Response to

Request for Additional Information No. 2, Revision 0

U. S. EPR Standard Design Certification

**SRP Section: 19 - Probabilistic Risk Assessment and Severe Accident
Evaluation**

Figure 19-43 - Example of Circular Logic: CCWS Common Header 1

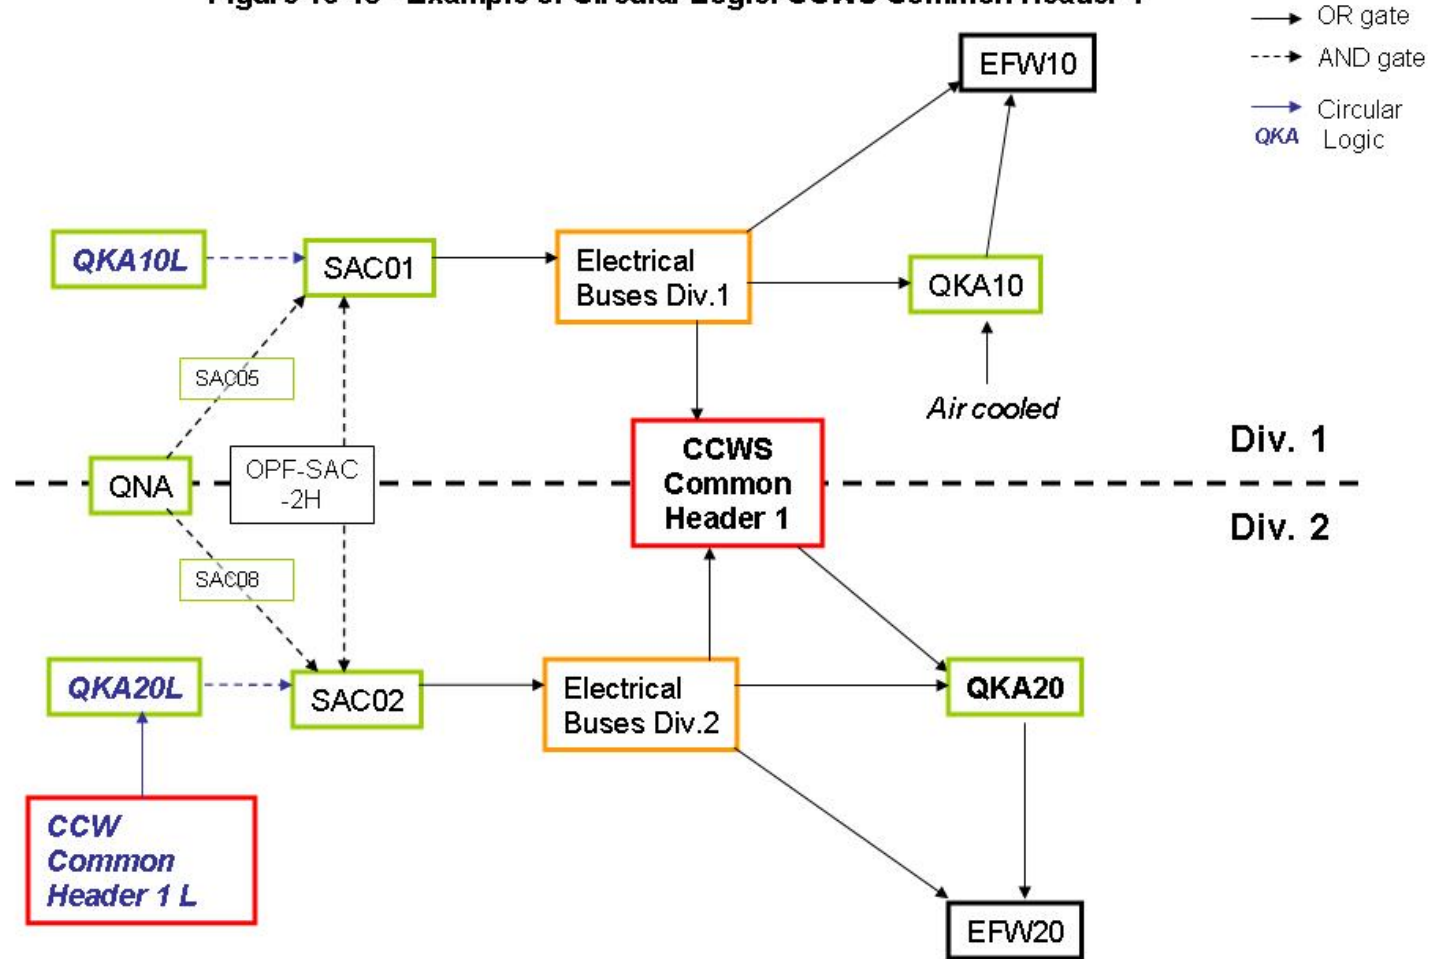
Please provide additional information on what types of electrical interdependencies between HVAC divisions may not be included in the model, as mentioned on page 19.1 57. What effect is this omission expected to have on the overall risk insights and conclusions?

Because of the circular logic, the above interdependency will not show directly in the PRA results. The total impact is expected to be small because HVAC Train 2 cooling to the EFW room properly captures this dependency, so that EFW Train 2 would be lost (one of the most important mitigating trains). The circular logic is illustrated in Figure 19-43 - Example of Circular Logic: CCWS Common Header 1.

Figure 19-46 - Example of Fault Tree Used to Evaluate Modeling Uncertainty

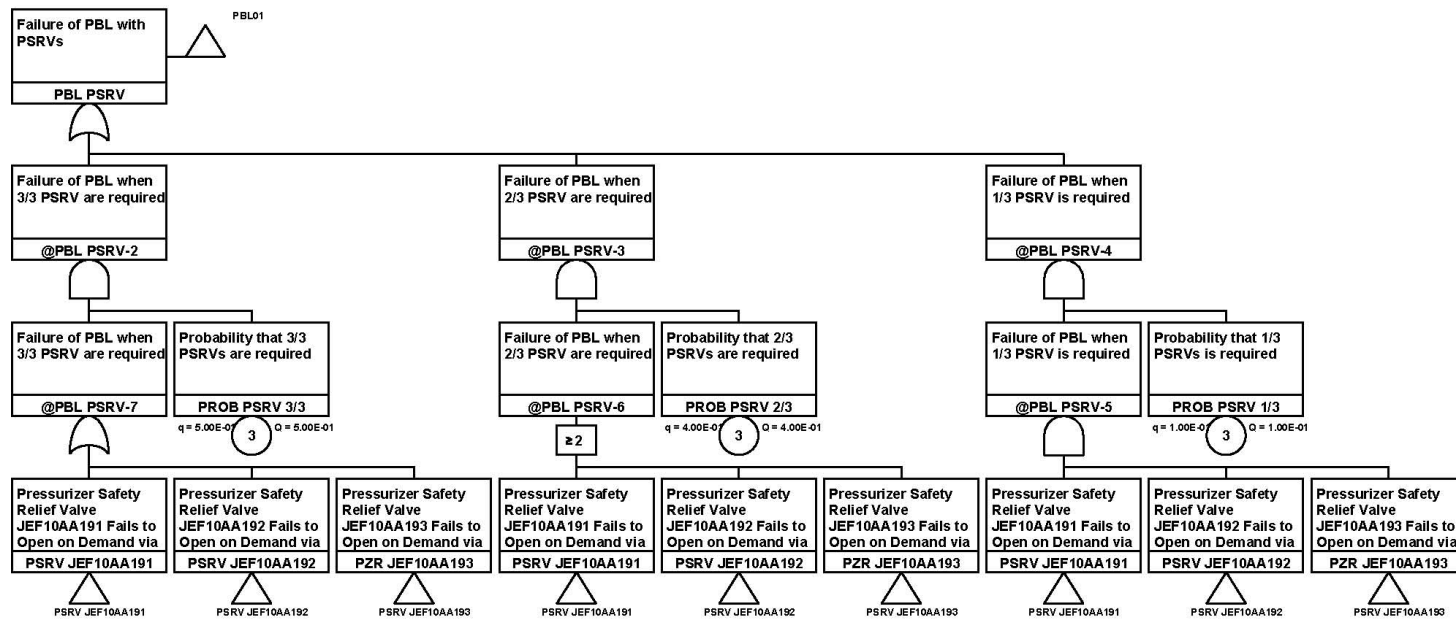
Please provide additional detail on the modeling uncertainty cases discussed on page 19.1-59 and 19.1-60. How was the probability of each success criterion derived? How is the subsequent weighted average modeled?

These cases are selected in order to identify possible uncertainties in the success criteria; they are based on the differences in the success criteria observed in global EPR PRAs. Corresponding probabilities are assigned based on engineering judgment. The different success criteria and corresponding probabilities are entered directly in the fault trees, as illustrated in Figure 19-46 – Example of Fault Tree Used to Evaluate Modeling Uncertainty. Therefore, the modified Risk Spectrum run has provided the weighted average.
